# Springbank Off-stream Reservoir Project:

climate change, hydrogeology, geochemistry & water quality

Jon Fennell, M.Sc., Ph.D., P.Geol.

On behalf of the Springbank Concerned Landowners Group

Maximum Flow in the Elbow River at Calgary (Below Glenmore Dam)

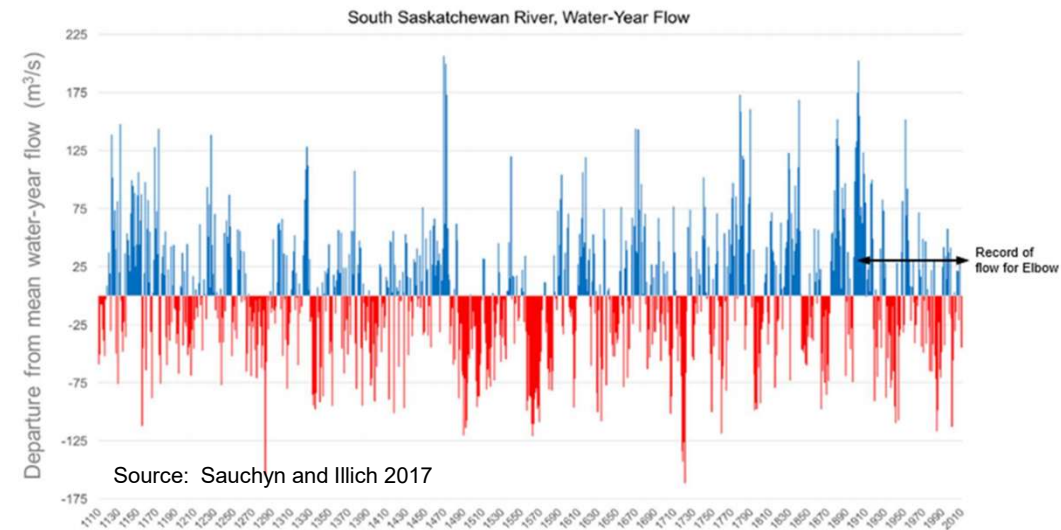
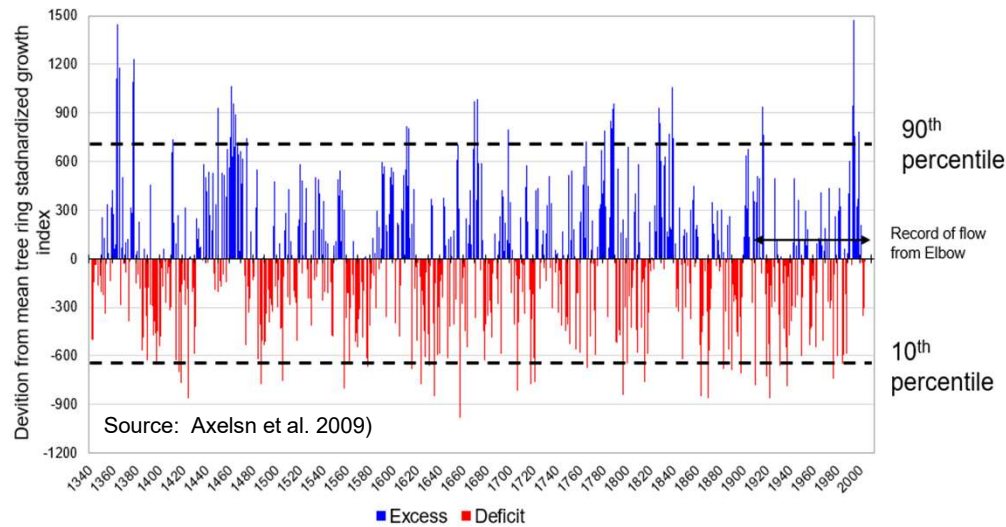
Large floods of record in the Bow Basin have not been captured in the record of the Elbow River *(does that mean they did not occur?)*

Comparison of documented floods on the Bow River indicates that flows in the Elbow River pre-dating the period of record could have been 2 or more times greater than the 2013 event.

Figure 10 of Exhibit 261, pdf pg. 18

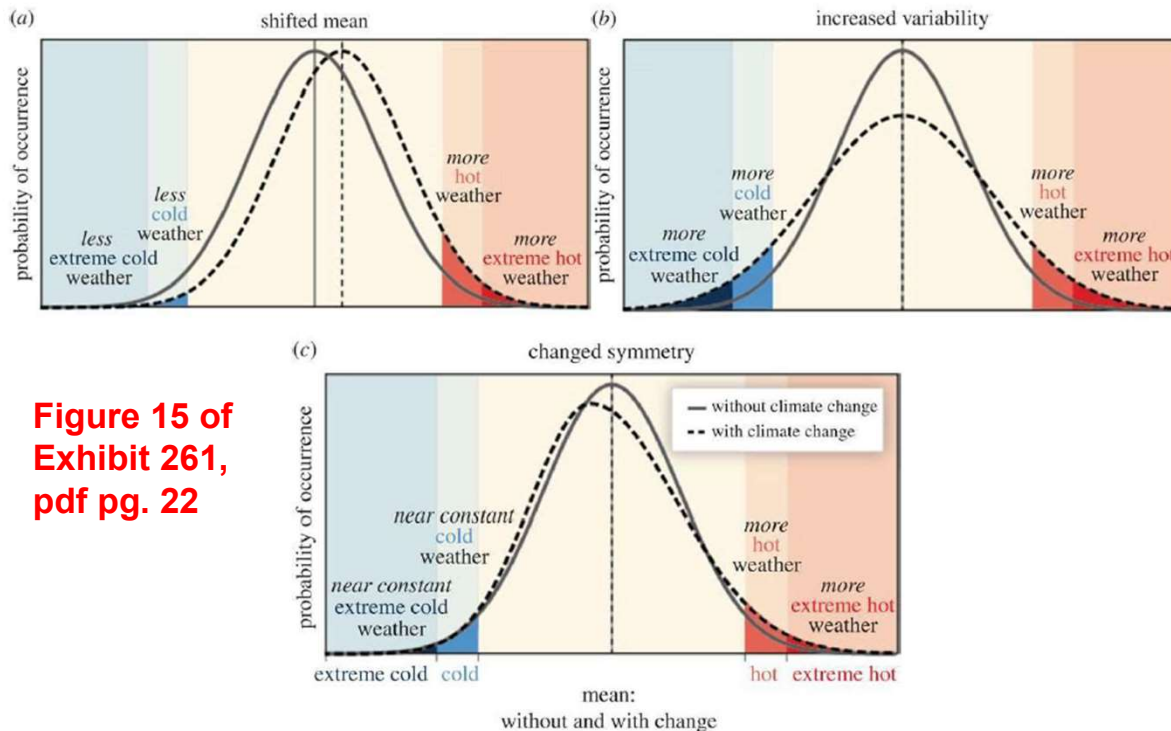
Paleo-records indicate numerous periods consistent with flood (above 90<sup>th</sup> percentile) and drought (below 10<sup>th</sup> percentile). Although this does not speak to individual events, it does speak to probability of occurrence (*i.e. floods and drought happen more during extended wet and dry periods, respectively*).

Figure 13 of Exhibit 261, pdf pg. 21

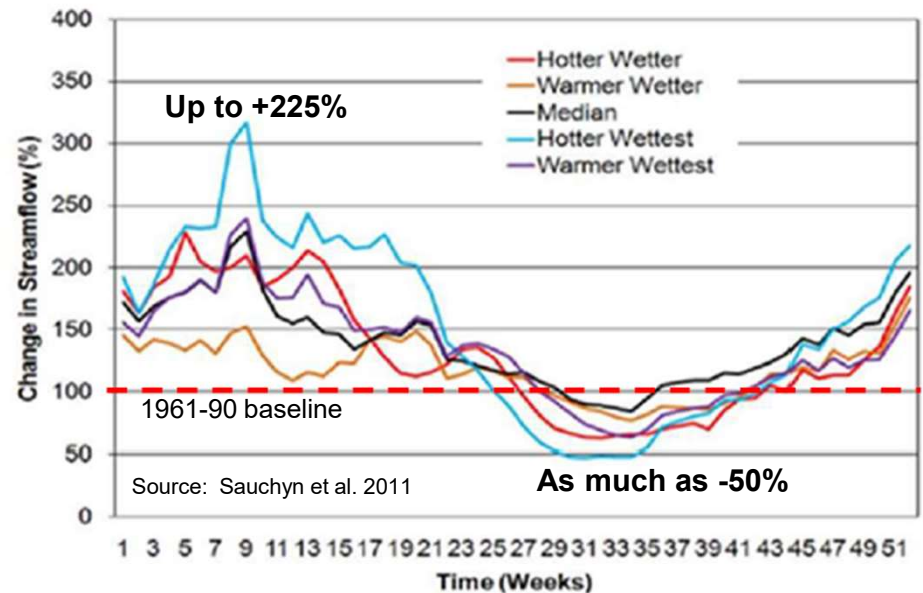
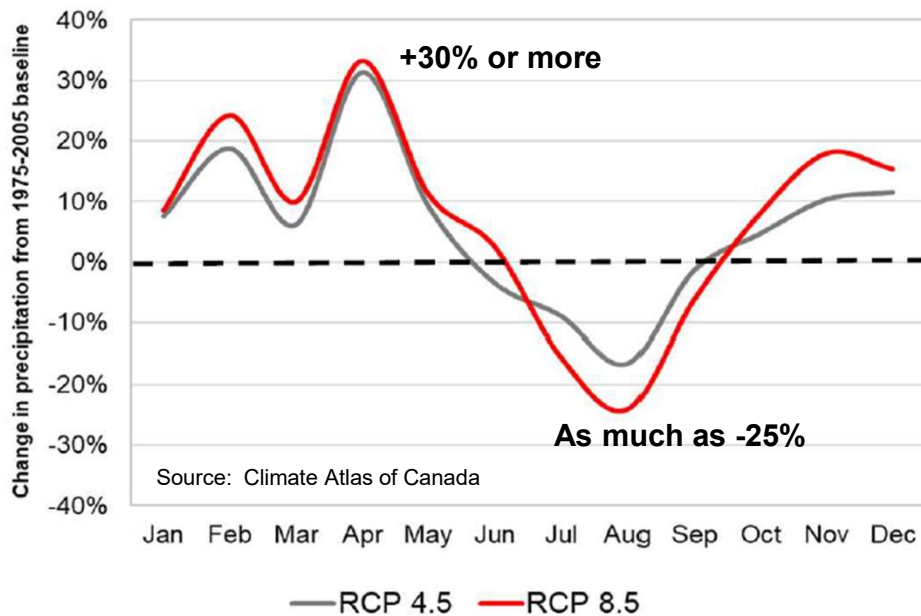
Projected shift in timing and magnitude of spring precipitation, as well as the anticipated change in river flow conditions, leads to an increase floods larger than 2013.

Figure 16 of Exhibit 261, pdf pg. 23

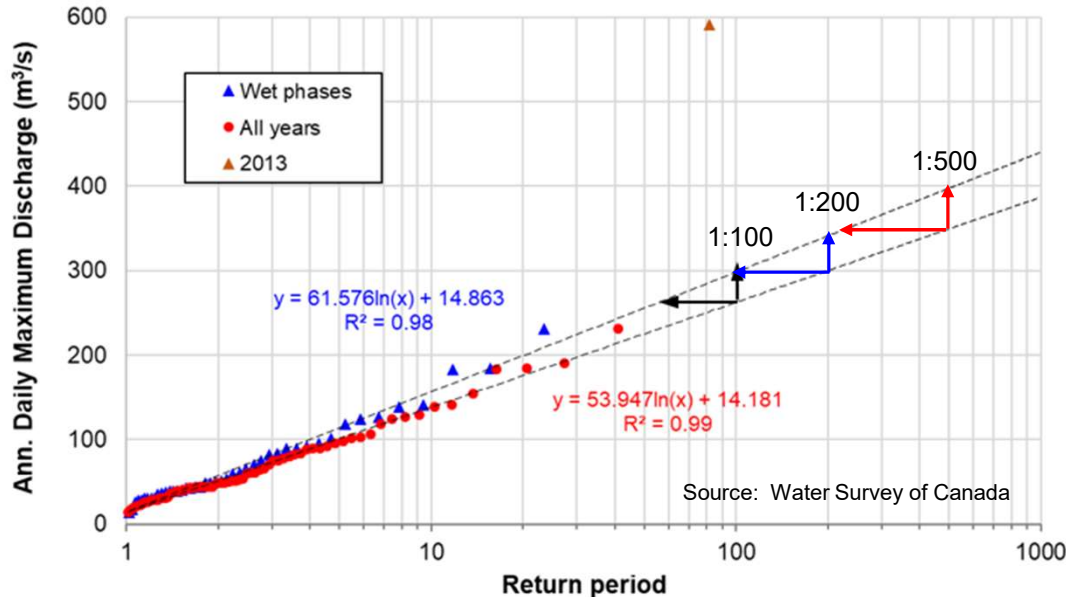
Flood statistics for wet climatic periods are very different from flood statistics generated from the entire period of record. Shortening of return periods results in increased risk of higher magnitude floods.

Figure 4-5 Hydraulic Conductivity Distribution in Layer 1

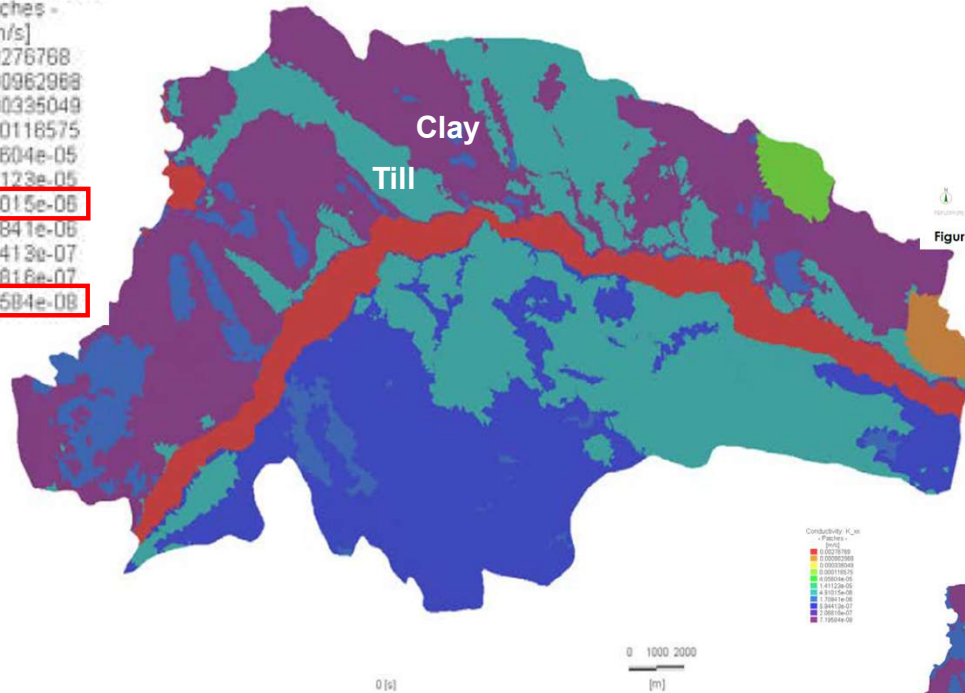
No sand & gravel added for the unnamed creek, leading to a concern regarding groundwater pathway constraints.

Exhibit 110 pdf pg. 121

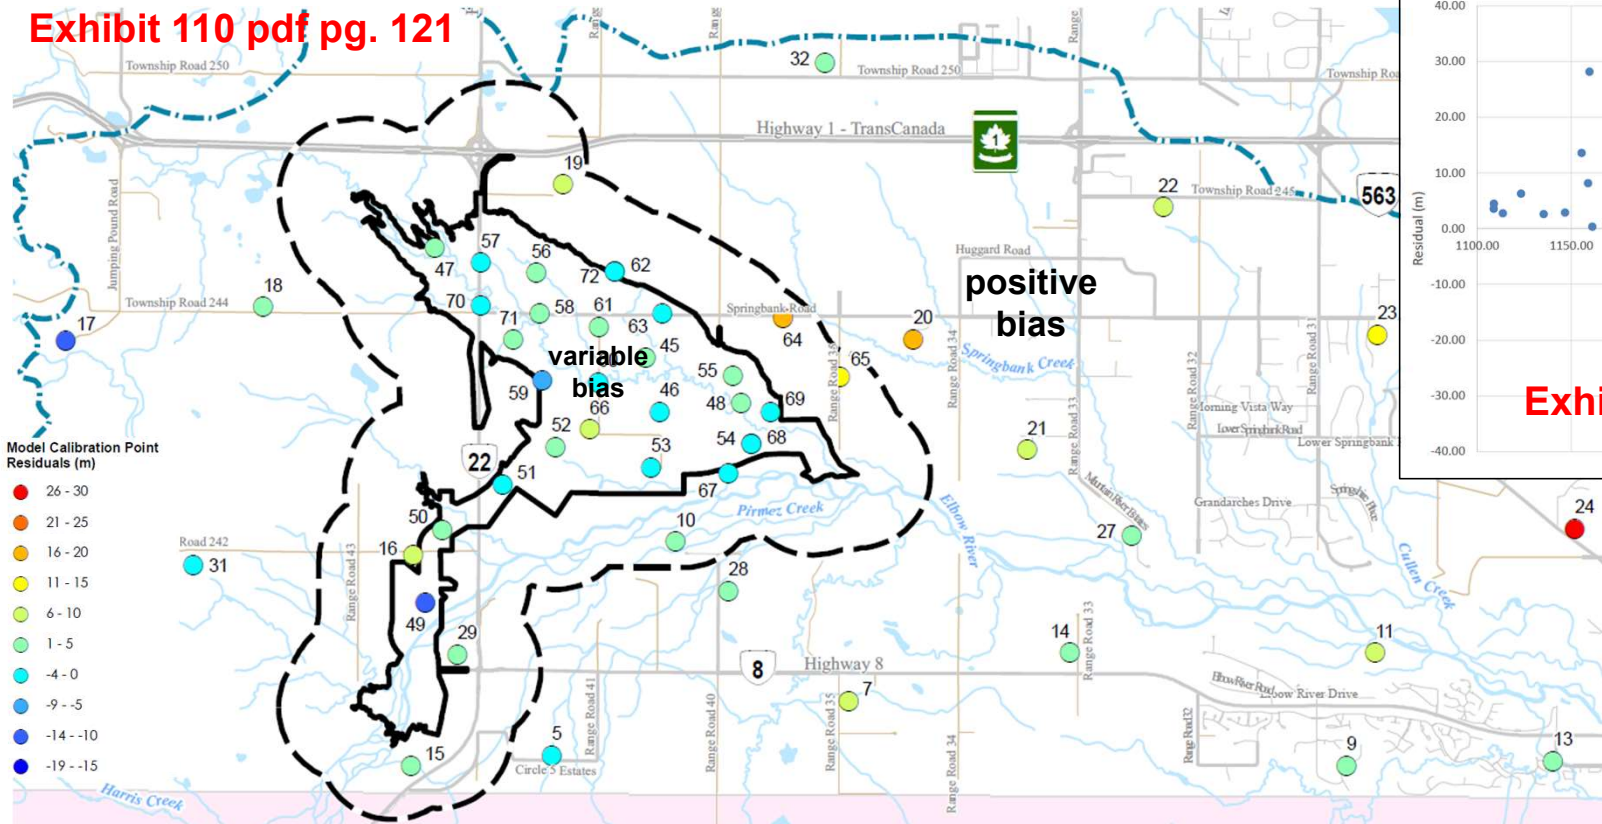
Despite contention that model results are acceptable, evidence of “positive bias” exists for calculated residuals, plus some spatial bias to higher residuals east of the SR1 indicating issues within model domain (reduced confidence).

Figure 5-7

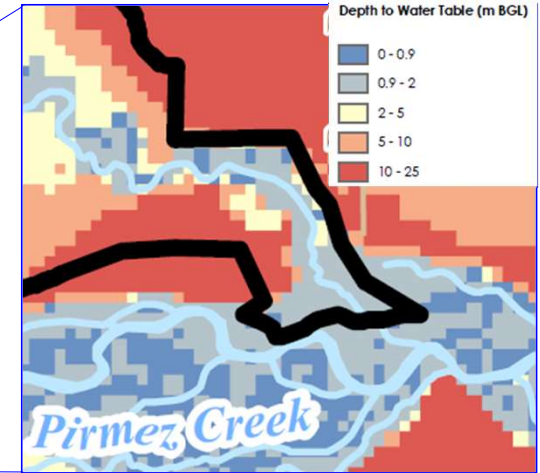
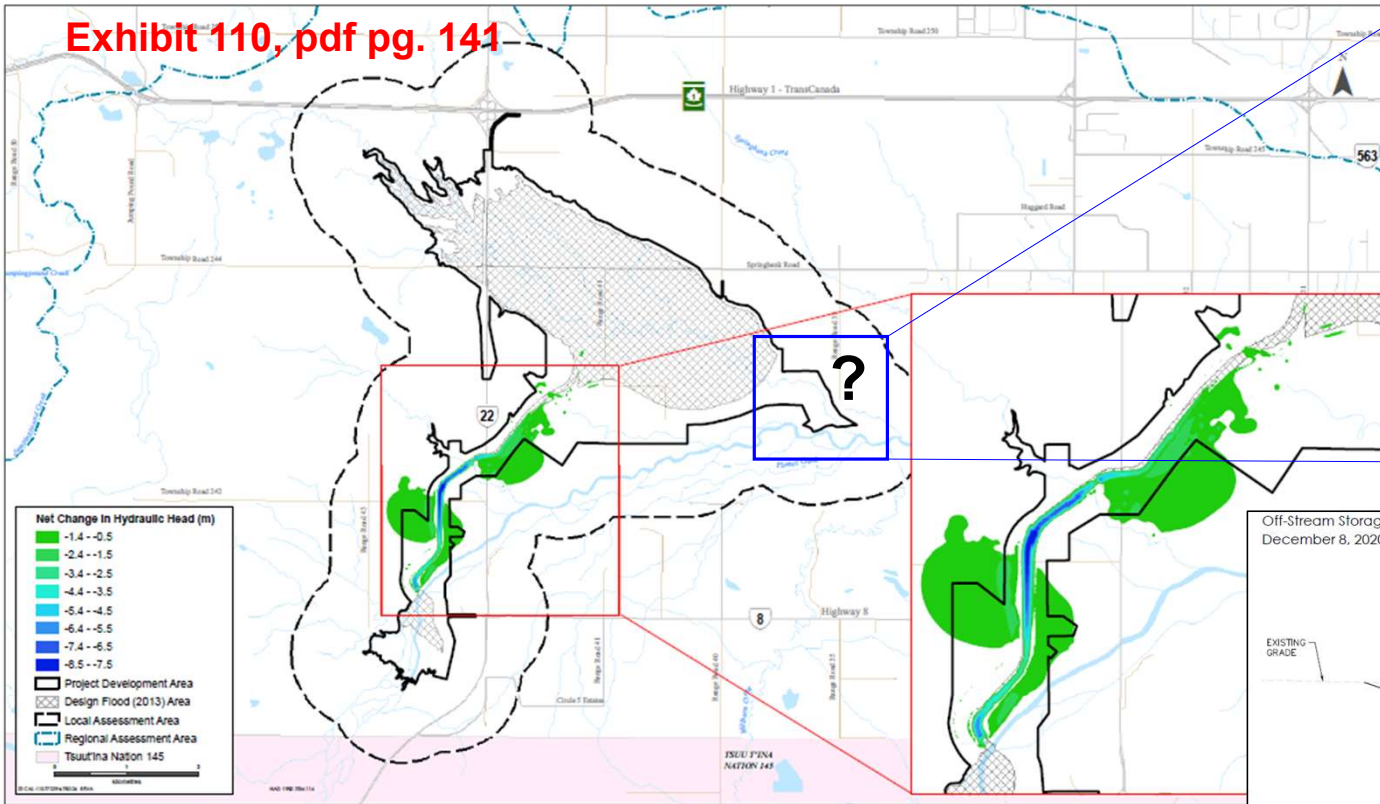
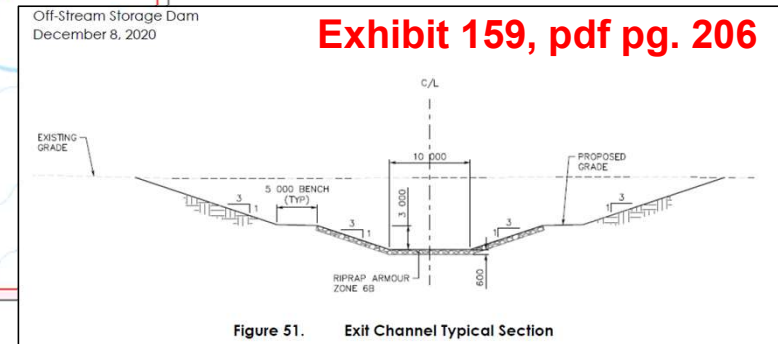
No drawdown impact identified around the SR1 outlet, even when an excavation 7 m or more below the water table is in place (*likely due to low K values selected*).

Figure 5-13

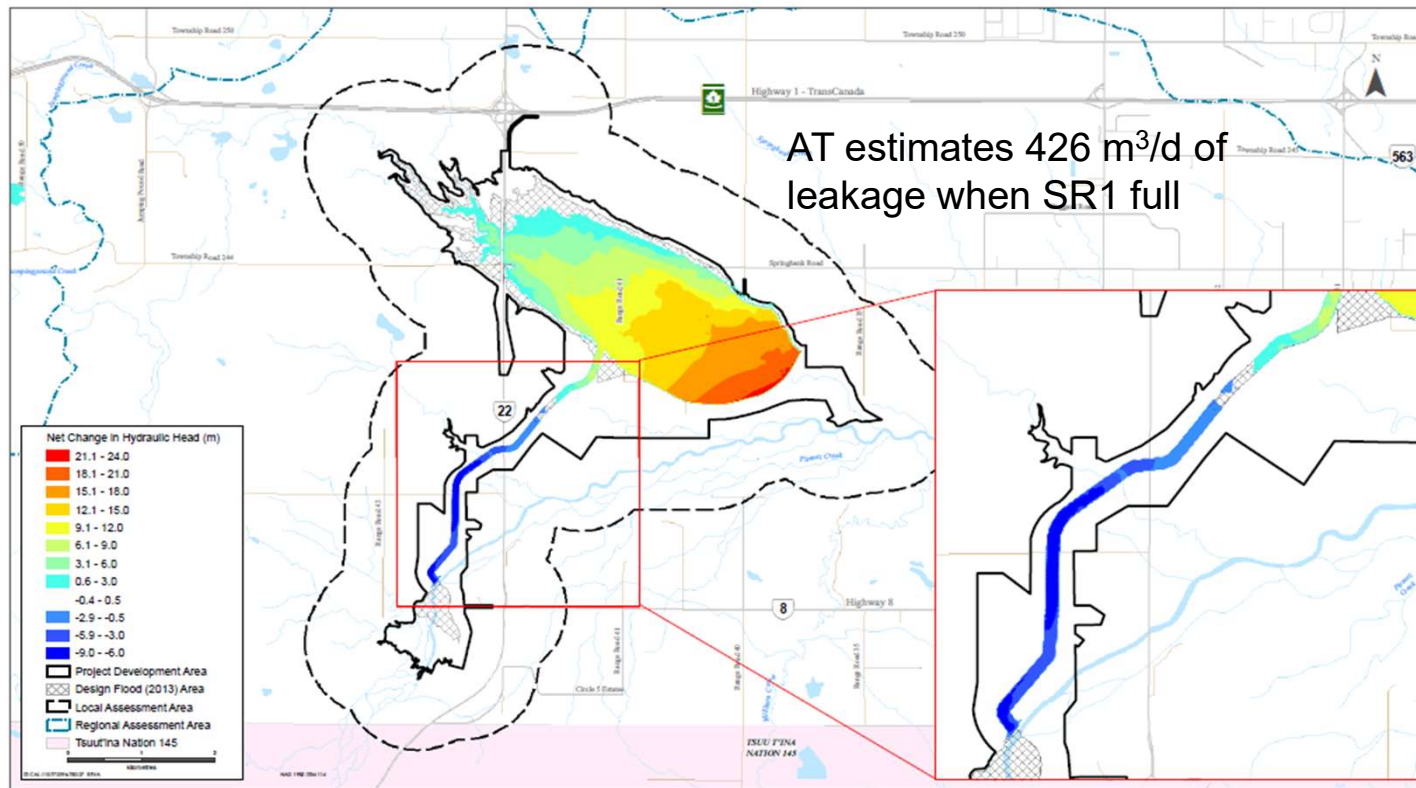
Increase in head of up to 24 m over areas + high depth to groundwater = greater leakage potential from SR1 when full or partially filled.

- Higher leakage estimates obtained when more appropriate K values used (*analytical calculations suggest over 100,000 m<sup>3</sup>/d; even more if "Till-high conductivity North" values in Table E.1-2 used*)
- Greater flushing of contaminants from or through clay/tills to bedrock and connected systems (*e.g. outlet channel to Elbow River*)

Exhibit 110, pdf pg. 75

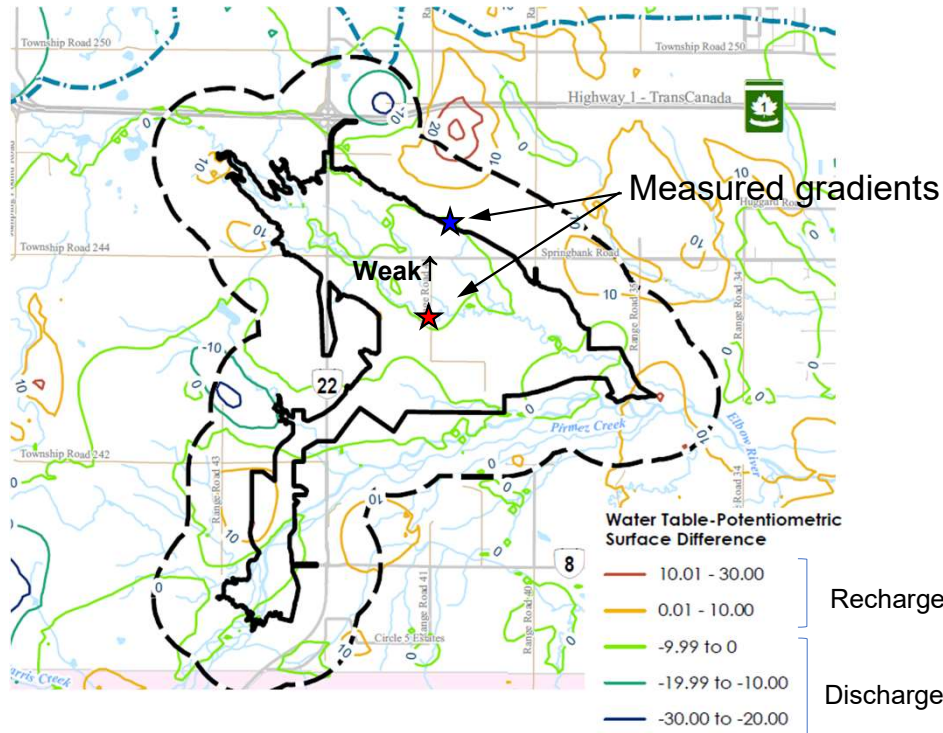
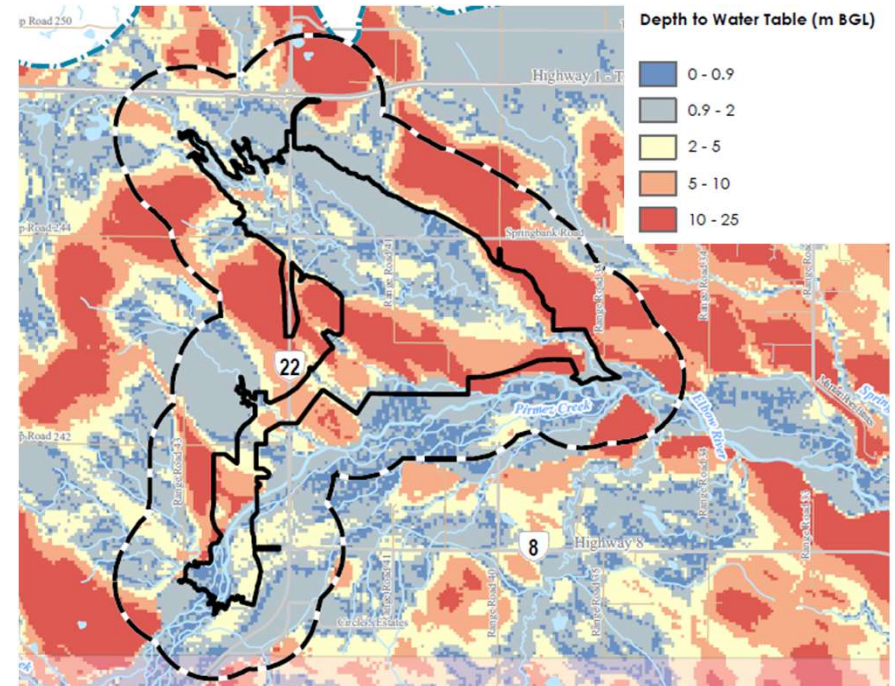
Mapping of vertical flow potential (*i.e. water table elevation minus potentiometric surface for bedrock*) indicates weak upward gradient beneath SR1, and variable conditions around perimeter.

Depth to water table generally greater than 1 m, and up to 10 m or more in some locations.
